**Columbia Generating Station  
Response to Request for Supplemental  
Information for PRNM LAR**

**NRC Public Meeting  
July 22, 2010**

<b>C3-ilex, LLC</b>			
Sales Order 7258, Columbia Generating Station PRNM Interface Project Configuration Drawing			
SIZE	FORM No.	DRWG No.	REV
B			
SCALE: NONE			SHEET 1 OF 1

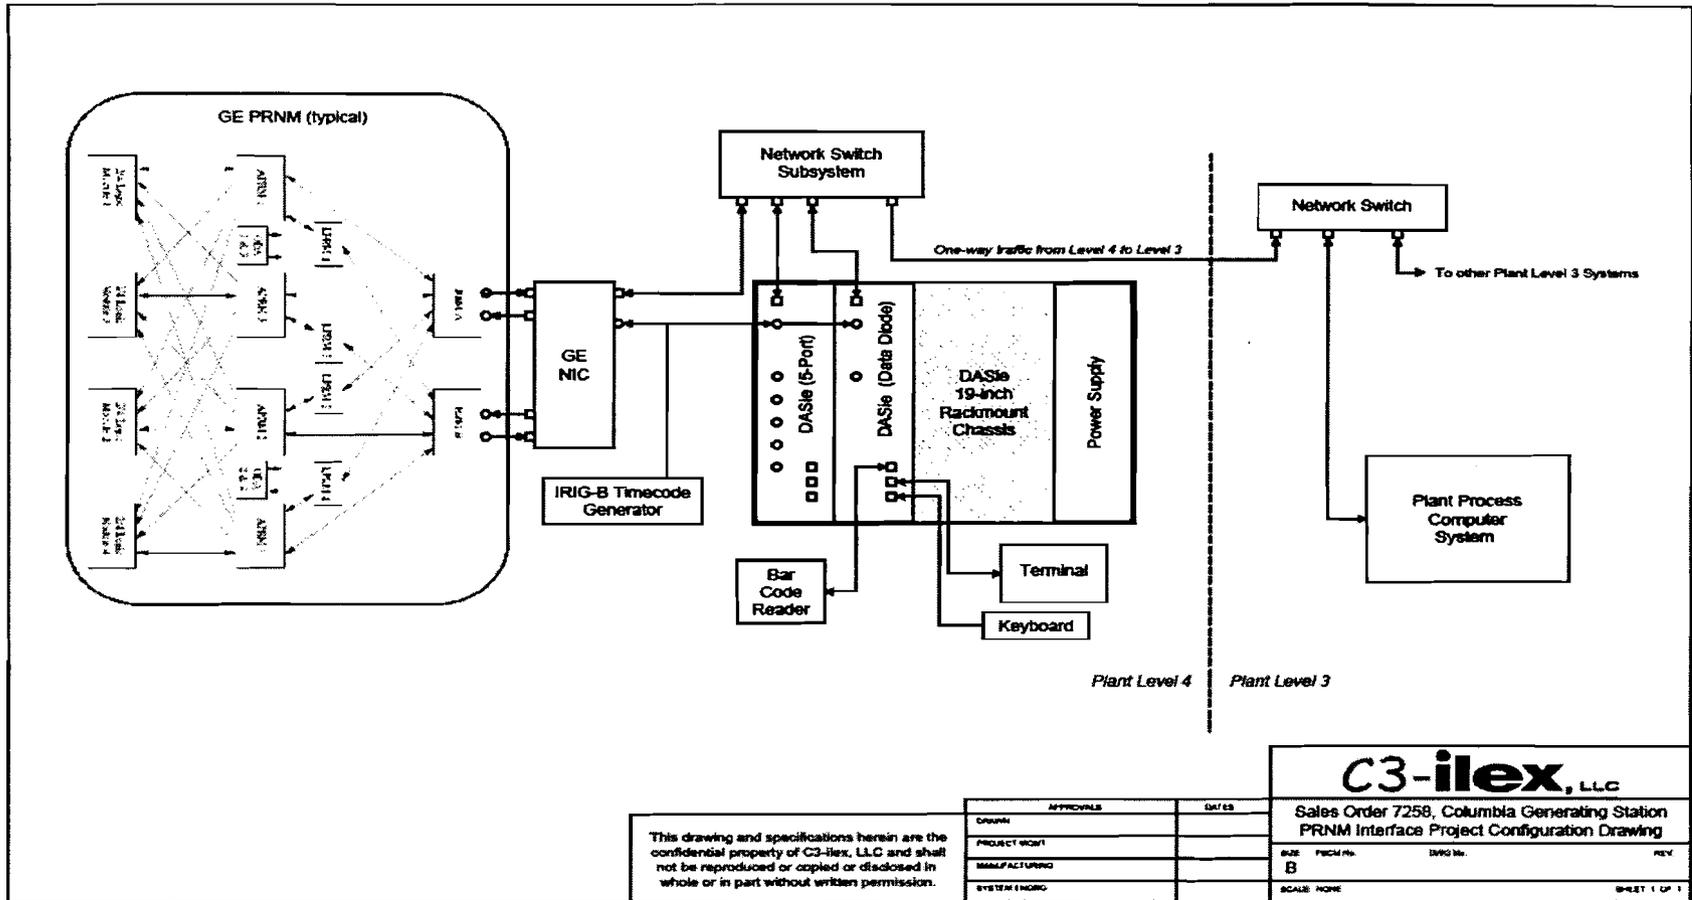
1. Identify and define all safety to non-safety communications, including data communications between PRNM, Plant Computer (PPC), and within independent PRNM channels.
2. Include a demonstration of compliance to ISG-04 for inter-channel communications.
3. Include demonstration of compliance to ISG-04 for communications between PRNM and PPC, as well as other inter-channel communications.

1. Communication paths to be identified. Pictorial representation of communications provided on next slide.
2. Compliance matrix with ISG-04 to be provided.
3. All safety related communications are internal to PRNM system and comply with ISG-04 requirements. Non-safety communications are limited (see next slide).
